County Board Agenda Item  
Meeting of November 13, 2010

**SUBJECT:** SP #220 SITE PLAN AMENDMENT to replace rooftop signs and relocate first floor conference space to second floor, and convert first floor conference room into additional retail space at 2500, 2514, 2530, and 2522 Wilson Blvd., N. Barton St. and Cleveland St. (RPC#: 18-007-011, -010, -008, -009, -006, -012, -029, 030)

PLA-5718

FIRST FLOOR PLAN

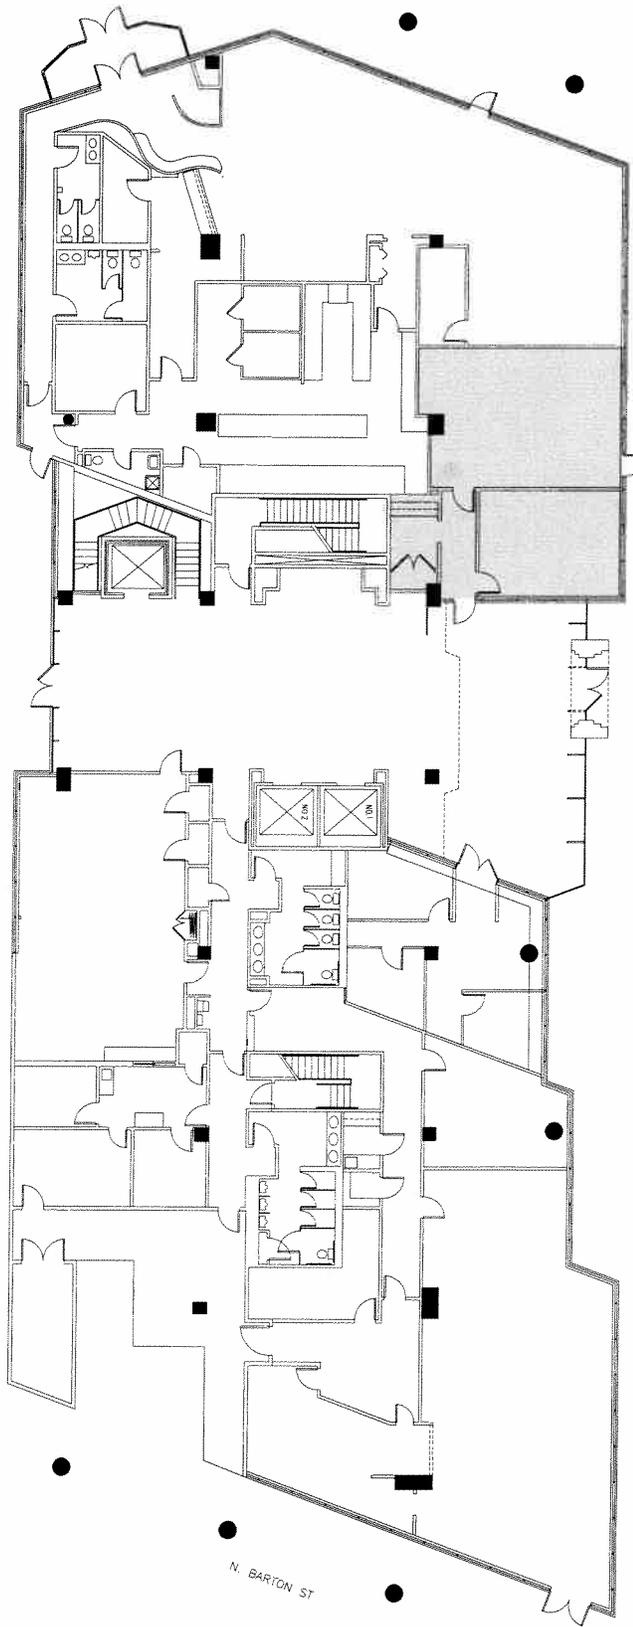
33. The applicant agrees that the approximately 1,050 sq. ft. space along Wilson Boulevard, previously used as a conference room and shown on the attachment titled “Lincoln Property Company Conference Room Location First Floor Plan” dated October 19, 2010 will be converted to ground floor retail space, as approved by the County Board on November 13, 2010. The applicant further agrees that the retail windows along Wilson Boulevard shall not be obstructed in any manner which precludes views into the interior of the space. The purpose of this condition is to allow pedestrians to view the activity within the retail establishment and to allow patrons and employees of the retail establishments to view the activity on the sidewalk and the street. This requirement shall not be satisfied by views into areas blocked by display cases, the rear of shelving, interior walls, blinds, or the like.

EXISTING CONFERENCE AREA  
(PROPOSED TO BE CONVERTED  
TO RETAIL)  
1,060 GFA  
*(first floor)*

SECOND FLOOR  
PLAN

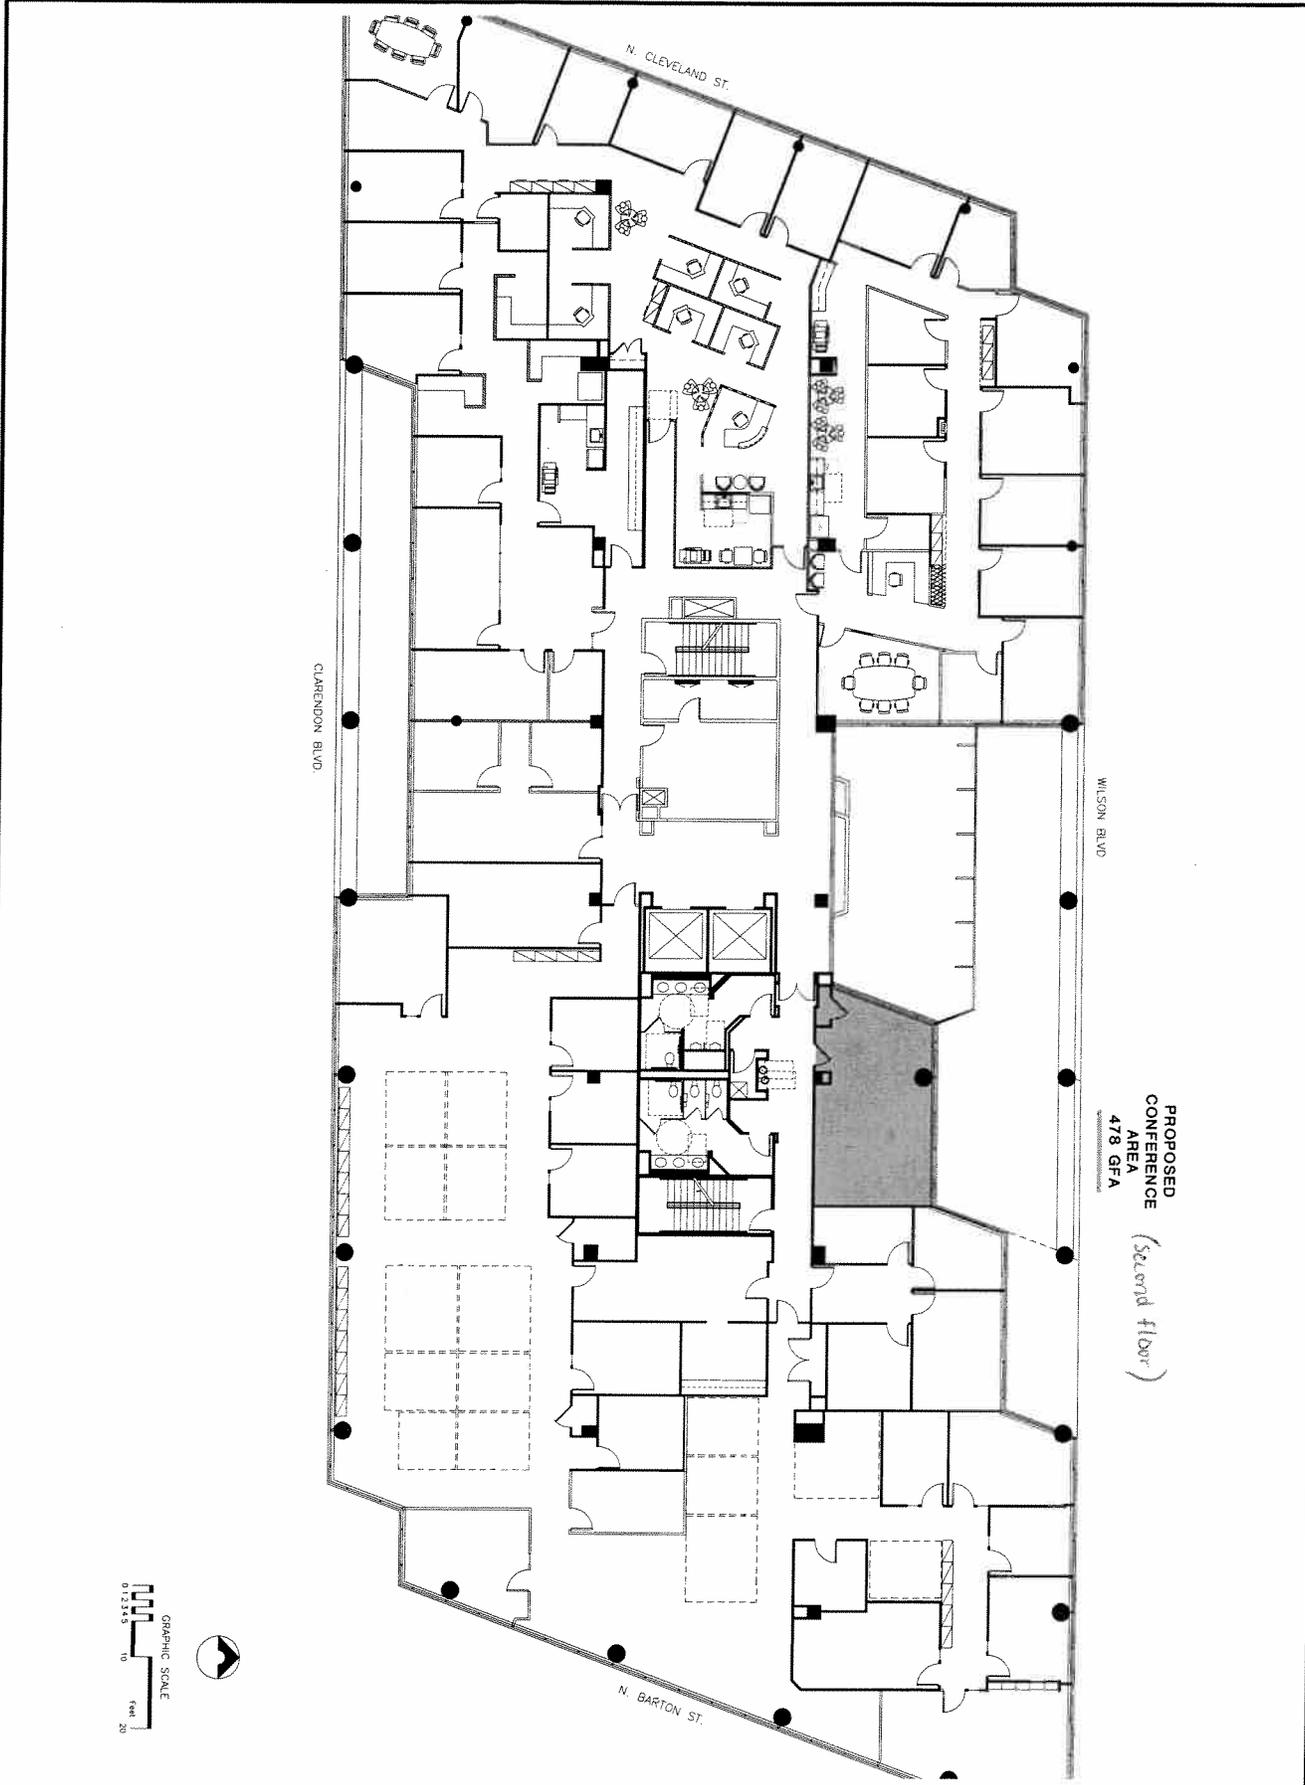
The conference space on the second floor would be smaller than the current approximately 1,050 square-foot space, at approximately 480 square feet. However, the new conference room will be located right off the second floor elevator lobby, which will make it easily accessible. The applicant will still be required, per approved Condition #29, to make the conference space available for use by the surrounding civic associations, condominium/homeowners/renters associations in the Courthouse area, and Arlington County Government, and to provide admittance of users to the conference space. Approved Condition #29 is provided at the end of the report for reference purposes.

PROPOSED  
CONFERENCE  
AREA  
478 GFA  
(Second floor)

LOCATION 2 & 4  
ILLUM. CHNL. LTRS.

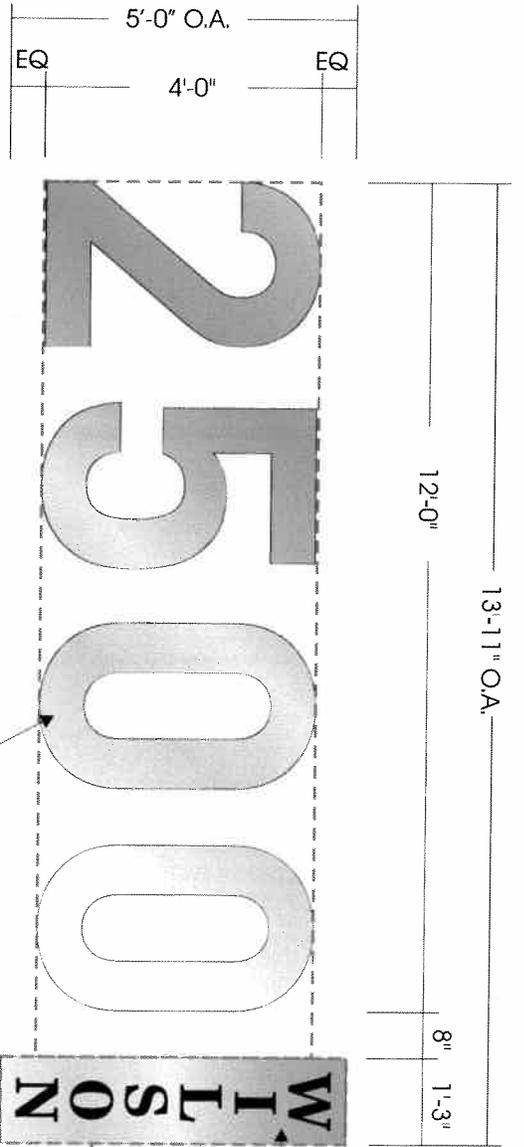
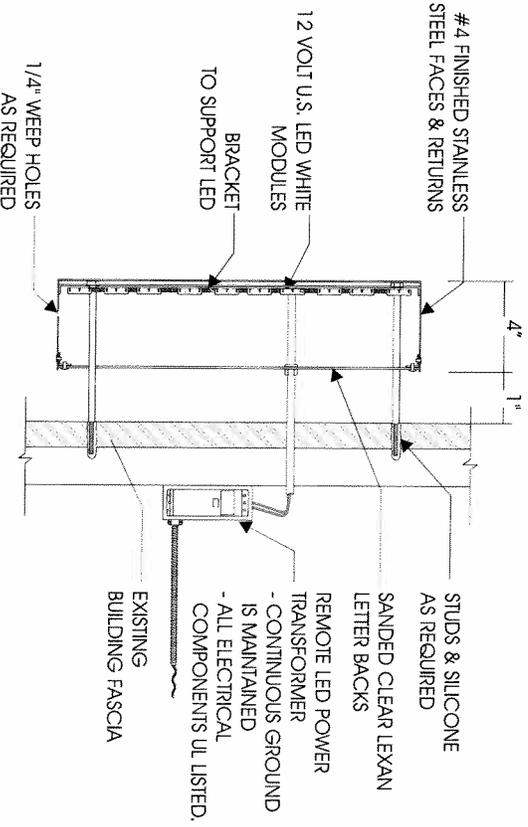
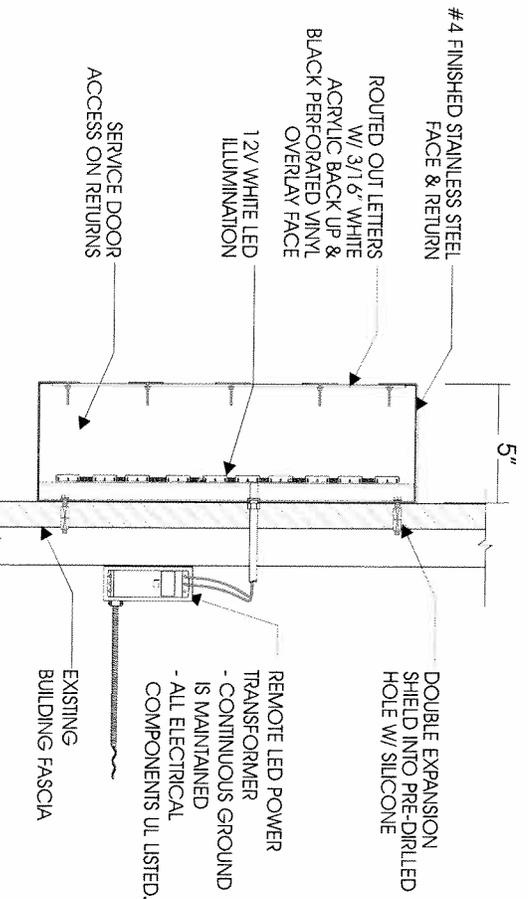
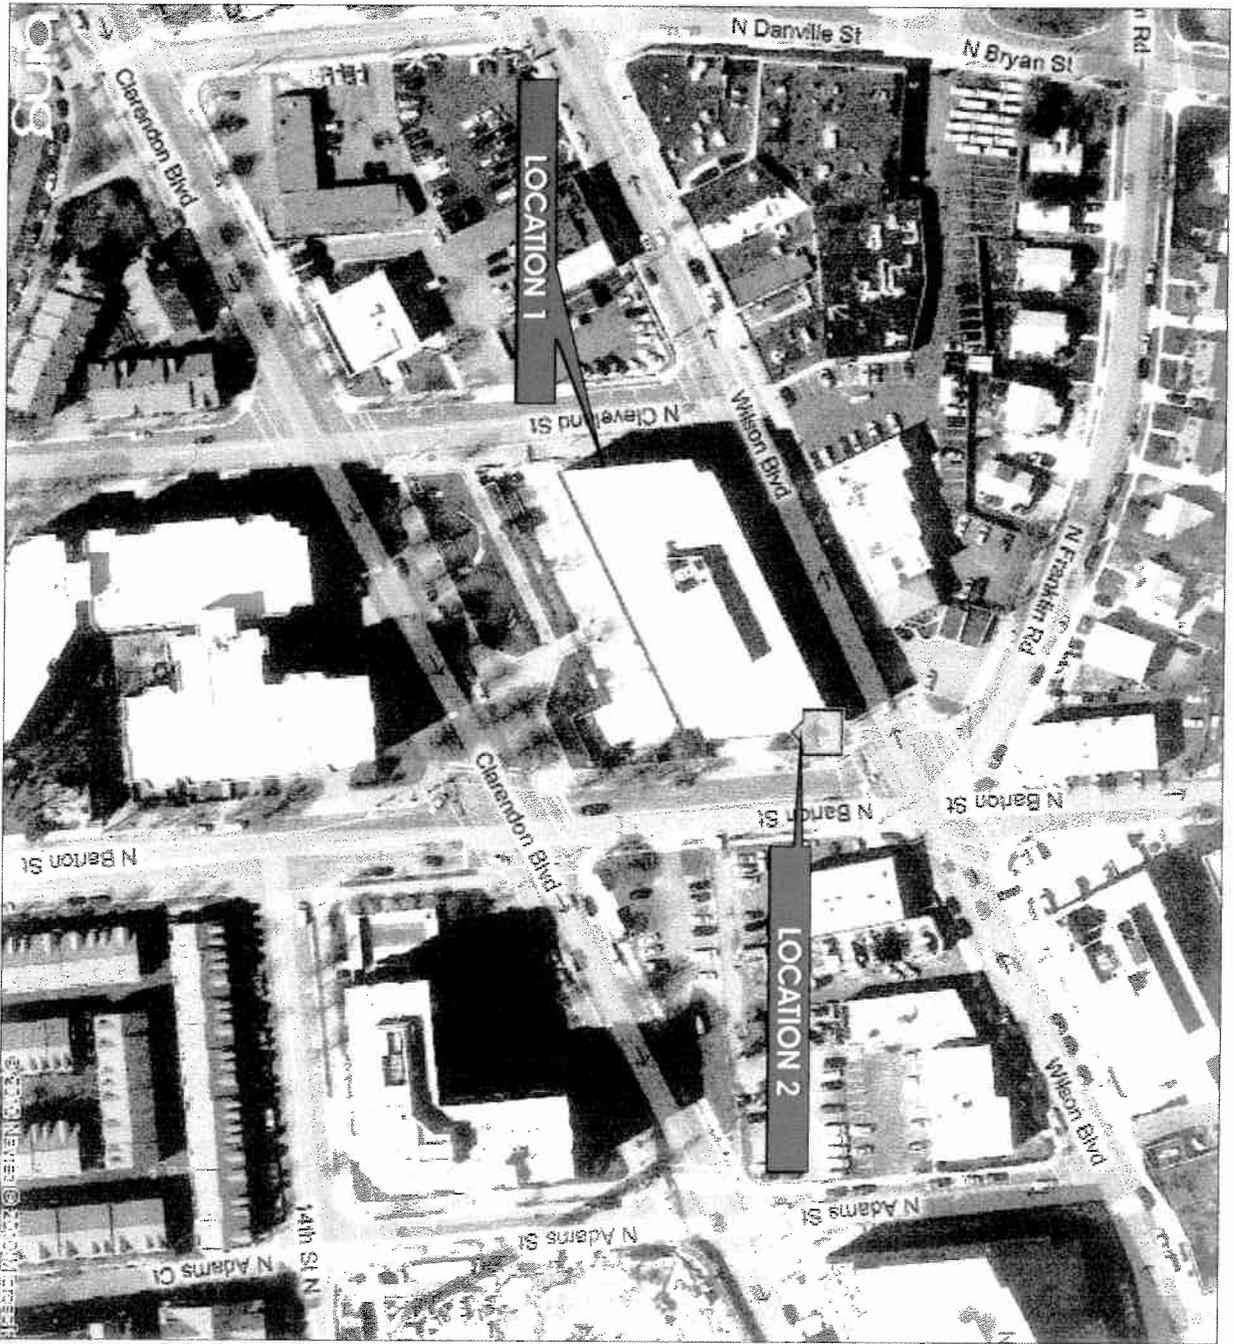
The Sign Guidelines state that two (2) rooftop signs are permitted per building and that the square footage is based on one (1) square foot per one (1) linear foot of building wall width  
SP #220 rooftop signs  
and convert conference space to retail  
PLA-5718

along the street frontage. The two (2) proposed signs are well within the sign area permitted for each sign. In addition, the proposed letter height is under the six (6) foot maximum recommended by the Sign Guidelines. Therefore, the proposal is consistent with the Sign Guidelines. In addition, the proposed signs will provide visibility for those traveling east on Clarendon Boulevard and west on Wilson Boulevard. The signs would be located in the same location as the existing EIA signs approved by the County Board in 1994 and 1995. Neither of the signs directly faces residential uses. The applicant has agreed to turn off illumination of the signs at midnight and incorporate a rheostat. With those new conditions, the new rooftop signs may have less of a visual impact than the previously approved rooftop signs.

**8-LINE CALCULATION**  
4.0' x 12.67' = 50.70 SF  
5.0' x 1.25' = 6.25SF  
56.95 SF / SIGN = 113.9 SF TOTAL

The applicant agrees that the two (2) rooftop signs shall be limited to the location and the same sign area rectangle as shown on the drawings prepared by Jack Stone Signs dated August 31, 2010 and approved by the County Board on November 13, 2010. The area of the rooftop signs shall not exceed 57 sq. ft. per sign, or 114 sq. ft. total for both signs.
